APPLICATION NO.	FILING DATE	FIRST NAMED INVENTOR	ATTORNEY DOCKET NO.	CONFIRMATION NO.
10/712,010	11/14/2003	Chin-Jung Chen	SUND 482	7872
23995	7590	09/20/2007	EXAMINER	
RABIN & Berdo, PC			TOTH, KAREN E	
1101 14TH STREET, NW				
SUITE 500			ART UNIT	PAPER NUMBER
WASHINGTON, DC 20005			3735	
MAIL DATE		DELIVERY MODE		
09/20/2007		PAPER

Office Action Summary	Application No.	Applicant(s)
	10/712,010	CHEN, CHIN-JUNG
	Examiner Karen E. Toth	Art Unit 3735

DETAILED ACTION

Wisniewski's Figure 1

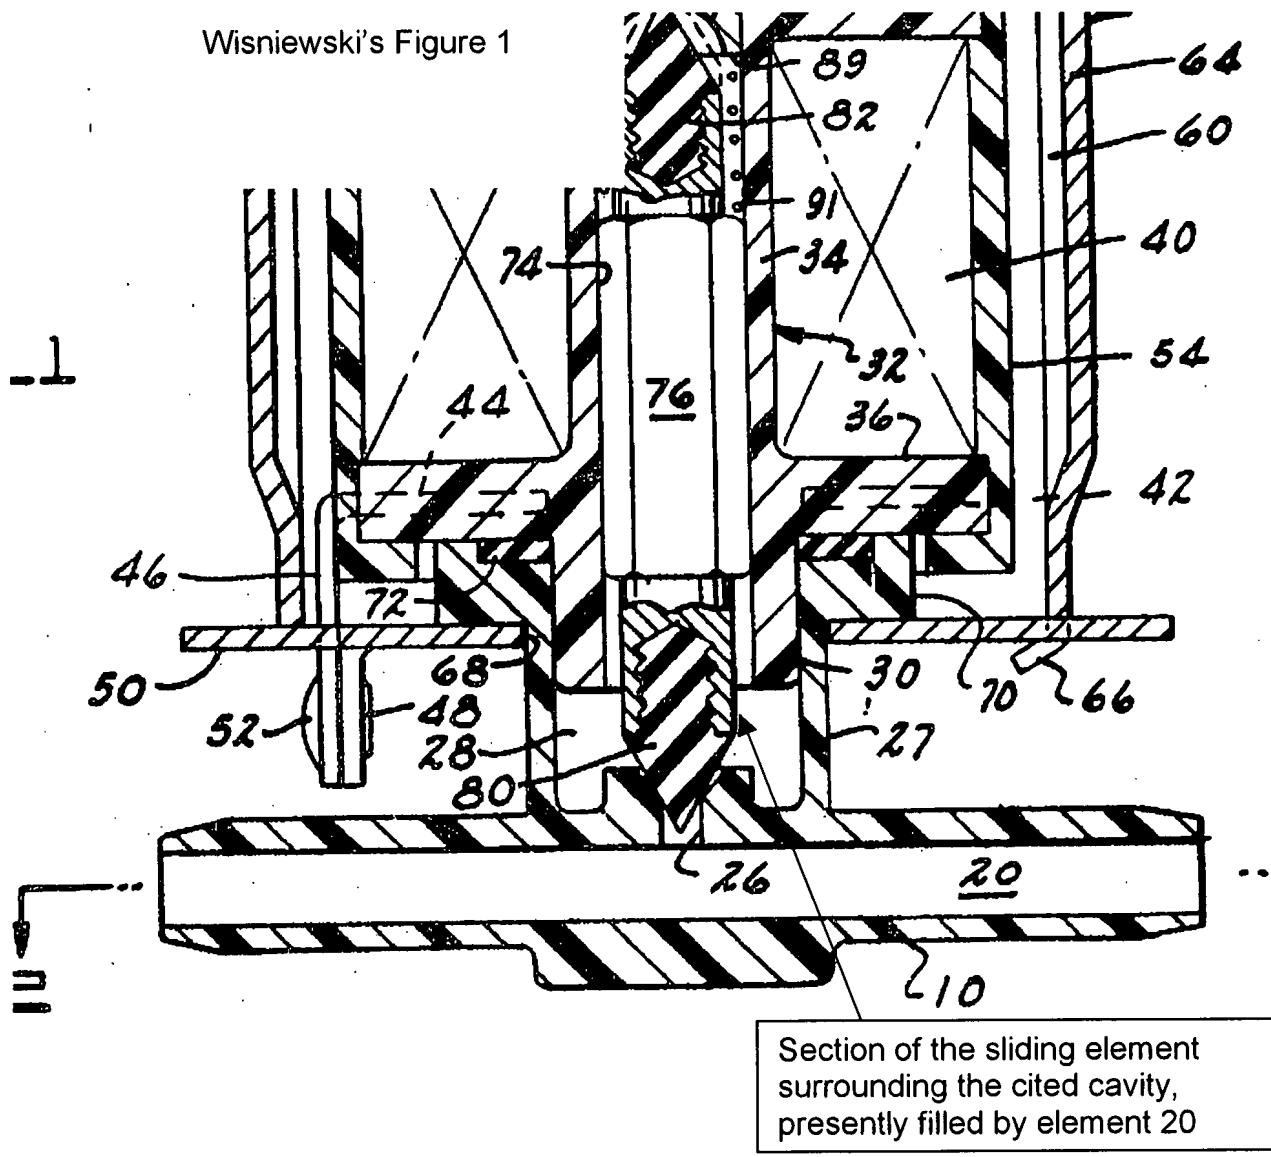
5. Claims 1 and 3 are rejected under 35 U.S.C. 102(b) as being anticipated by Wisniewski (US Patent 3459404).

Wisniewski discloses an air-pressure adjusting device that has an outlet (element 26) comprising a driving element, such as an electromagnetic coil (column 2, lines 10-14); a shifting element (generally represented as element 76) coupled to and driven by the driving element and that has a cavity (column 2, lines 65-67; cavity is the interior of the portion shown with skinny diagonal lines surrounding element 80 in figure 1 – see illustration below); and a deformation element disposed at the cavity of the shifting element (element 80); where the deformation element exerts a force to cover the outlet according to a degree of the displacement of the shifting element, the deformation element may be deformed into the cavity upon displacement of the shifting element, and the deformation element controls the amount of air released to adjust an air pressure (column 1, lines 31-33).

Applicant has argued that Wisniewski's elastomeric tip cannot deform "into" the device's cavity because it is partially secured in the cavity. The Examiner disagrees – because the tip is elastomeric, it can inherently be further compressed into the cavity, as would happen upon application of force against the outlet.
